Technical Bulletin

Model: Multi-Folding Unit FD4000	Date: 17-May-12	No.: RD615001c

Model: MT-C5 Multi-Folding Unit FD4000 Date: 26-Oct-12 No.: RD615002

Subject: Wrong	knob decal		Prepare	d by: K. Yamamoto
From: 1st Tech S	Service Sect., MFP/Printer Tech	n Service Dept		
Classification:	☐ Troubleshooting☐ Mechanical☐ Paper path	☐ Part informate ☐ Electrical ☐ Transmit/rec		☐ Action required☐ Service manual revision☐ Retrofit information
	☐ Product Safety	☐ Other ()	☐ Tier 2

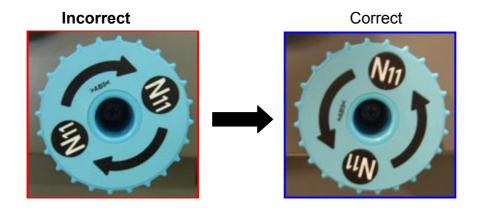
The arrow on the jam recovery knob (circled in red below) was printed on the knob in the wrong direction.

The parts vendor mistakenly printed the arrows for all four knobs (shown above) pointing in the same direction. In fact, the arrows on the jam recovery knob should be pointing counterclockwise, and those on the other three are pointing clockwise.

Replace the decal for the jam recovery knob (D6157111) with the correct one at machine installation or the next service visit. See **Affected Serial Numbers** below.
